Technical Car Construction Regulations

Changes for 2018 and Beyond

Version 1.1 (Published) – 9th October 2017

New Update Engine Offset

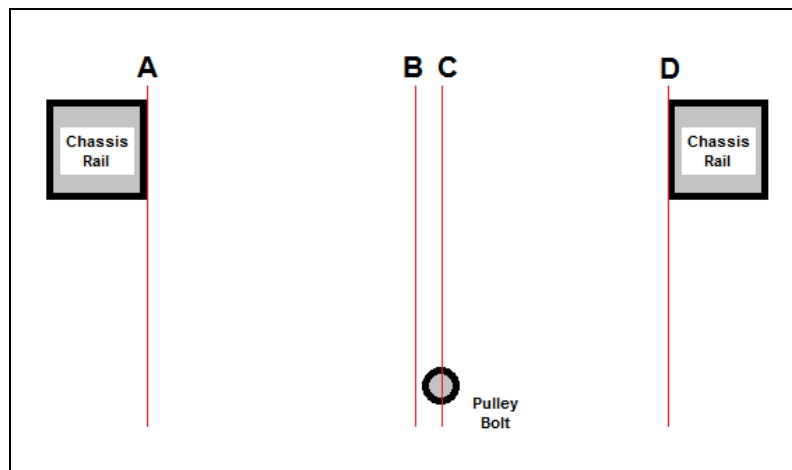
- A diagram will be included in the rulebook to clarify the method of measurement for engine offset (similar to below).
- The existing wording will be updated to specify that...

- Measurement is to be taken horizontally from the vertical plane of the centre of the crank pulley bolt (C) to the vertical plane of the inner edge of each chassis rail (A) and (D) when the chassis is sat level. *[These planes will only be vertical if the chassis is sat level, so raising up one side of the chassis to make the chassis rails level may be required. Alternatively measurements can be taken using a square/straight-edge, from a straight-edge place across the chassis rails, thus removing the effect of the ground/surface not being level.]*

- The two measurements (C to D, and C to A, in the example diagram below) MUST NOT differ by more than 50mm.
 - Halving the difference between the two measurements (C to D, and C to A in the diagram below) will give the offset from the vertical plane of the centreline of the chassis (C to B).

- The distance from the centreline of the chassis MUST NOT be more than 25mm.
